Intersection ID: 12489	Main Street: CHESTNUT_AV	Cross Street: NASSAU_BV	Location:	NW
ADA ID: 6CC0EEC197AA	Ramp Type: PerpDiag	Initial Pass/Fail: Fail	Overall Compliance: No	Severity Score: 12.5

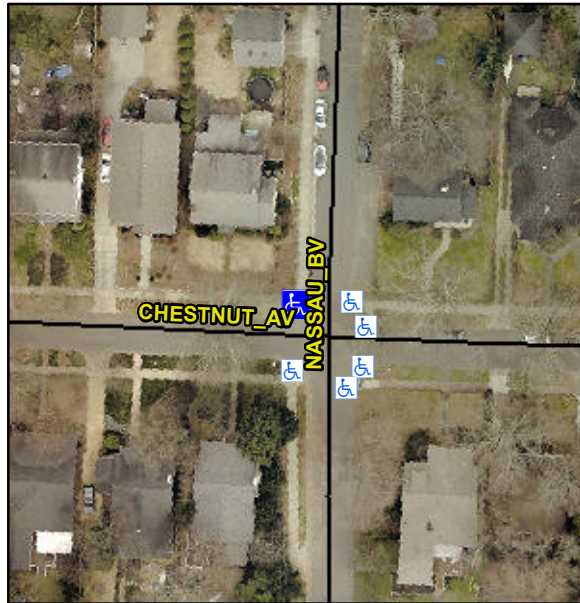
**Not Found, R304.2.2**

Compliance	Description	Data	Compliance	Description	Data
N/A	Ramp Length (in)	69.0	No	Ramp Slope (%)	9.2
Yes	Ramp Width (in)	48.0	Yes	Ramp XSlope (%)	0.6
N/A	Flare Type LT	N/A	N/A	Flare Type RT	N/A
N/A	Flare Slope LT (%)	N/A	N/A	Flare Slope RT (%)	N/A
N/A	Flare Traversable LT?	N/A	N/A	Flare Traversable RT?	N/A
N/A	Landing Length (in)	N/A	N/A	DWS Provided?	N/A
N/A	Landing Width (in)	N/A	N/A	DWS Contrast?	N/A
N/A	Landing Slope (%)	N/A	N/A	DWS Length (in)	N/A
N/A	Landing X Slope (%)	N/A	N/A	DWS Full Width?	N/A
N/A	Landing Curb? (Y/N)	N/A	N/A	DWS Offset (in)	N/A
N/A	Shared Landing?	N/A			
N/A	Gutter Ponding?	Yes	N/A	Gutter Slope (%)	N/A
N/A	Gutter Lip Ht (in)	N/A	N/A	Gutter X Slope (%)	N/A
N/A	Painted X Walk1?	No	N/A	Painted X Walk2?	No
	X Walk 1 Direction	To S		X Walk 2 Direction	To E
N/A	X Walk 1 Width (in)	N/A	N/A	X Walk 2 Width (in)	N/A
	X Walk 1 Slope (%)	1.6		X Walk 2 Slope (%)	0.8
	X Walk 1 X Slope (%)	1.5		X Walk 2 X Slope (%)	0.1

**Remove & Replace Curb Ramp With Two New Directional Ramps or Equivalent.**
